V. C. Summer Nuclear Station

Individual
Plant Examination
for
Severe Accident
Vulnerabilities

**RESPONSE TO NRC
QUESTIONS
1996**

**RESPONSE TO THE NRC REQUEST
FOR ADDITIONAL INFORMATION
ON THE VCSNS IPE**

Comparison of V. C. Summer and Zion cavity configuration.

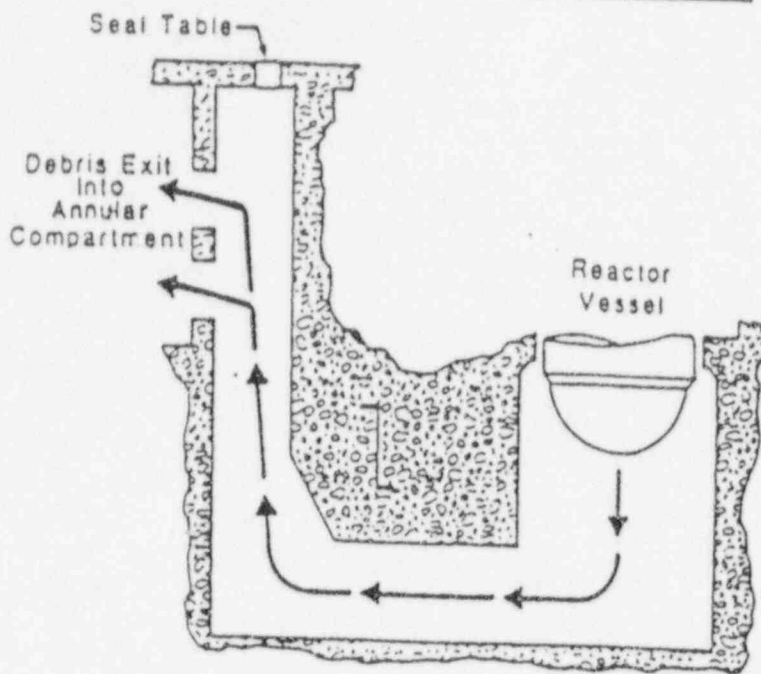
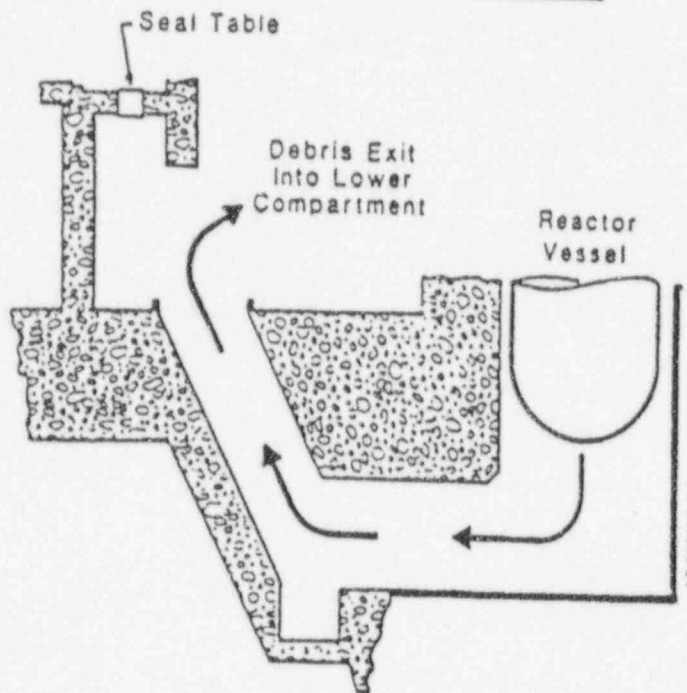
1) It is stated in the IPE submittal that "Comparison of VCSNS and Zion cavity/instrument tunnel designs clearly indicates that the VCSNS geometry would trap and de-entrain more debris than in the Zion configuration." Please provide a more detailed discussion by comparing the cavity configurations of the two plants and point out the similarities and differences that support the above claims.

V.C. Summer Cavity Configuration

Zion Cavity Configuration

*Above Figures are in approximate Scale with Each Other.

Sketchs For Back End Question 2

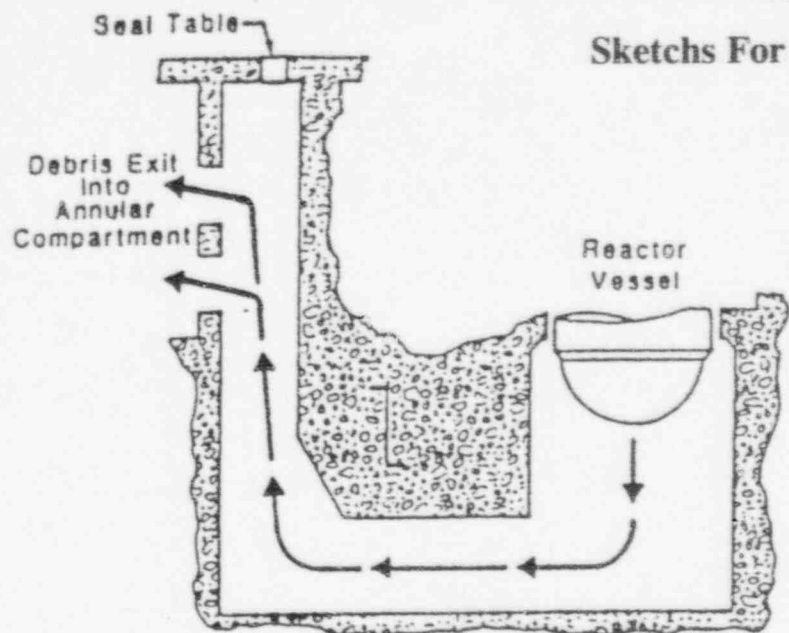
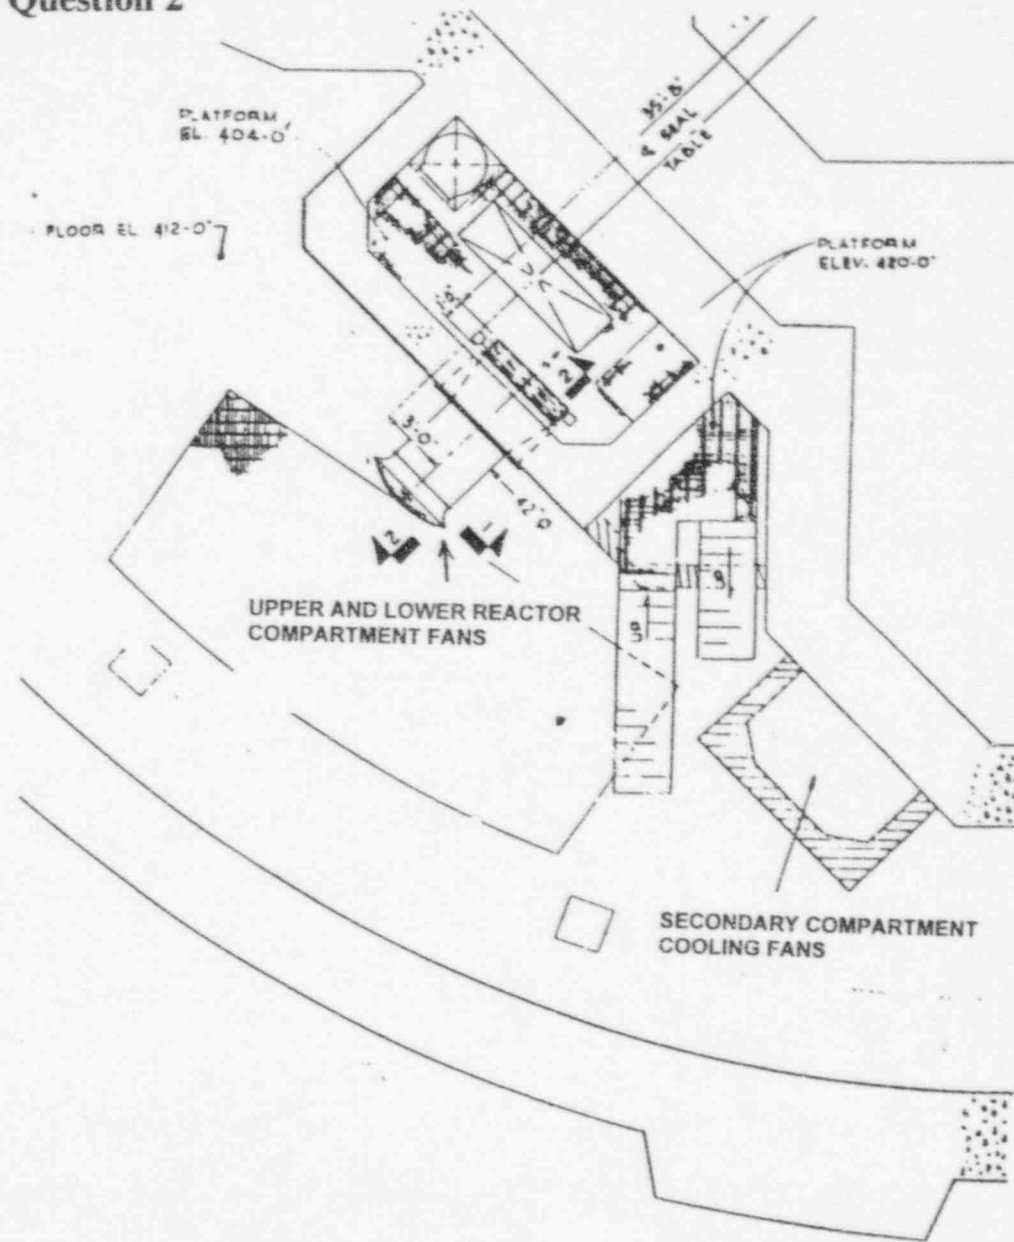
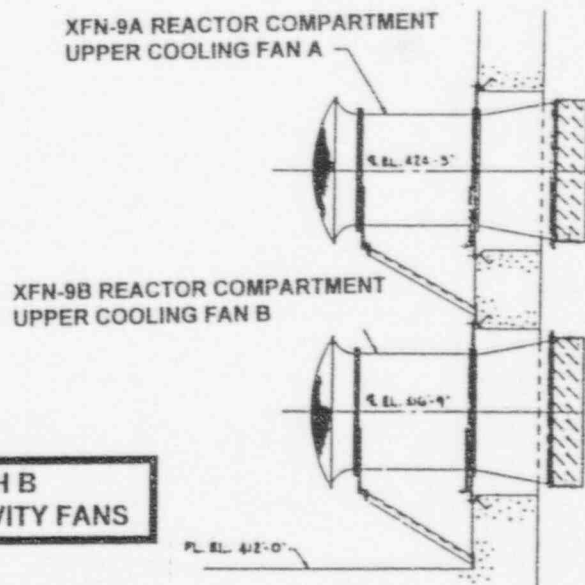
2) According to the IPE, the majority of the core debris will be de-entrained by containment structures and remain in the cavity during high pressure melt ejection (HPME). Please provide a more detailed discussion of the debris flow path and debris distribution during HPME. Please include in the discussion the effect of the two cavity cooling fan openings, which, according to the IPE submittal, connect the lower compartment and the reactor cavity (through the instrument tunnel, Figure 4.2.1-5) and allow water on the lower compartment floor to flow to the reactor cavity. Please discuss the effect of these openings on the dispersion and distribution of core debris after vessel melt-through and, consequently, any adverse effect on containment integrity or equipment availability.

The first step in assessing the Debris Distribution is the determination of the entrained mass which occurs concurrent with the gas discharge from the failed vessel under high pressure conditions. The entrained mass is proportional to the square root of the RCS pressure and size of the breach. Under conservative assumptions derived from an assessment of a Station Blackout, a mass of 41759 kg was calculated. This mass which is carried in the gas flow stream is swept across the cavity floor, turning 90° and then directed through the instrument tunnel where it impacts the seal table and its enclosure. Located below the seal table along the instrument tunnel wall are the two reactor cavity cooling fan openings. The gas flow stream would then make a second 90° turn and enter the two openings from which it could be expelled into the containment annular region, after it passes through the fan units themselves.

At each of the two 90° turns and passage through the fan units, a fraction of the originally entrained mass is de-entrained due to impact with structures. The V. C. Summer analyses took credit for de-entrainment at only one of the two 90° turns and assumed the remaining mass was released to the containment atmosphere as particulated debris capable of reaching thermal equilibrium with the containment atmosphere thus resulting in a pressure rise.

The de-entrainment factor calculated for a single 90° turn was 86.5%, and was based on the work of J. V. Walker as documented in NUREG/CR-5039, SAND 87-2411, "Reactor Safety Research Semi-Annual Report." Thus 41759 kg of debris was originally entrained, and 86.5% was de-entrained at the first 90° turn resulting in 5,637 kg traveling through the instrument tunnel, through a second 90° turn without any de-entrainment and through the fan cooling units, again without de-entrainment and finally into the containment gas space.

SKETCH A
VCSNS CAVITY CONFIGURATION

SKETCH C
CAVITY FAN LAYOUT

SKETCH B
REACTOR CAVITY FANS
